M25 junction 10/A3 Wisley interchange TR010030 8.3 Statement of Common Ground with Environment Agency

M25 junction 10/A3 Wisley interchange

8.3 STATEMENT OF COMMON GROUND WITH ENVIRONMENT AGENCY

Figure 1 Flood extent sensitivity

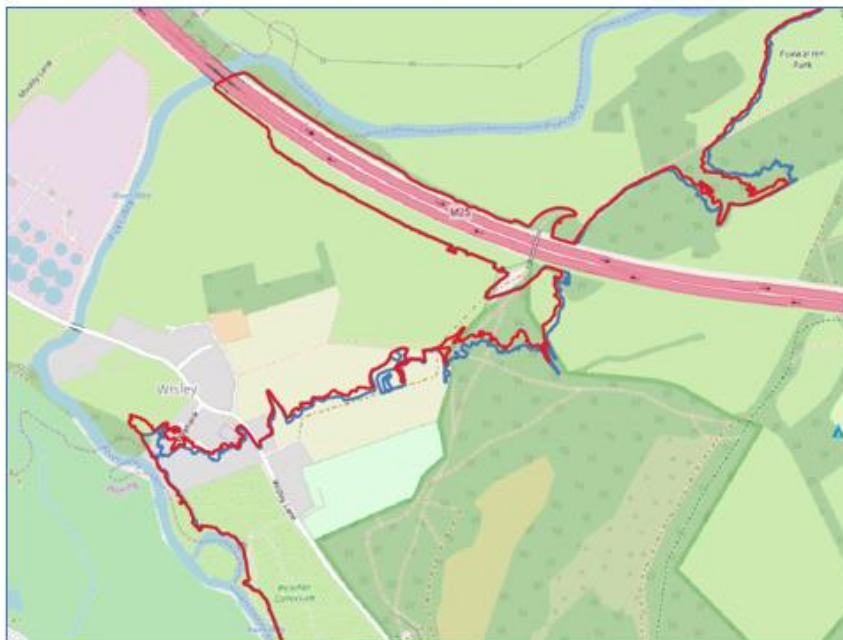
There is then the underlying issue of the design standard for the Scheme. The design standard is the 1 in 100 +35% flood event. In accordance with the DMRB and the Flood risk assessment requirements, the 1 in 100 +70% has also been tested. The 1 in 100 +35% flood levels do not interact with the Scheme. The 1 in 100 +70% flood levels do interact with the scheme. The only place where this occurs is the western most approx. 40 m of the embankment on the southern side of the M25 near Buxton Wood Footbridge (for reference, sheet 11 of 31 of the Scheme Layout Plans). The trigger for changing the design to accommodate any potential impacts at the 1 in 100 +70% event needs to be done on the basis of probability and consequence and it's this principle that informs the relevant conclusions of the FRA. It is particularly this point that I would like to discuss to understand how we can come to an agreement on the outstanding issue.

The results from the model runs show that the increase in baseline peak flood levels from the 1 in 1000 event to the 1 in 100 +70% is approximately 160 mm. Figure 1 shows the change in flood extent on the right bank of the River Wey for a 160 mm increase in level above the 1 in 1000 flood levels. The red line is the 1 in 1000 flood level and the blue line is the 1 in 100 +70% flood level. Only the right bank of the River Wey has been shown as this is the part of the floodplain nearest the Scheme and therefore the only place where the proposed Scheme could be influenced by a significant change in the flood extent.

The difference between the 1 in 1000 and the 1 in 100 +70% flood extents is minimal, with no substantive change in the baseline flood extent nor flood risk. The change in flood extent would be expected to be smaller than shown in the figure for the reasons described above.

Figure 2.2: Stratford Brook with modelled 1 in 100 +35% flood extent

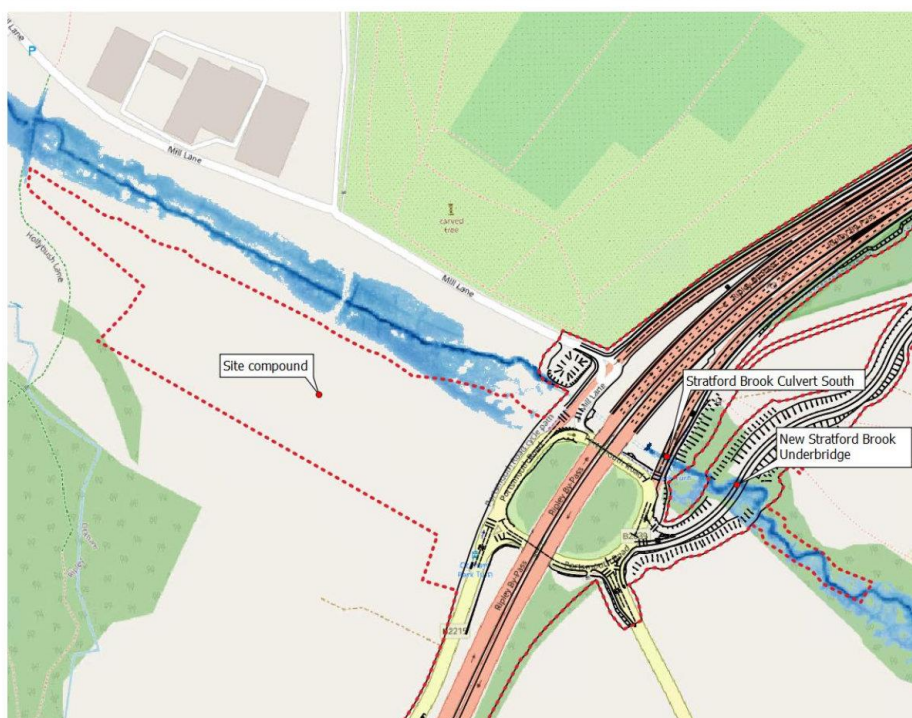
3.1.6	WFD Assessment Comments Log (CL): 028	Stratford Brook Crossing	Paragraph 5.4.3 of the WFD report states that “the bridge deck should run perpendicular to the watercourse (to reduce shading)”. The EA are	The planform of Stratford Brook at the New Stratford Brook Underbridge is shown on Sheet 1 of the Scheme Layout Plans	Agreed

- 2.4.41 As shown in Figure 2.2, there is a small extent of the DCO boundary, within Flood Zone 3 of the Stratford Brook. The DCO boundary here is associated with a construction compound. The DCO boundary is set simply as an offset from the river and the compound will be outside the Flood Zone 3.

- 2.4.13 The Scheme near Stratford Brook is illustrated in Figure 2.2. Further detail of the Scheme is shown on sheet 1 of 31 of the Scheme Layout Plans.
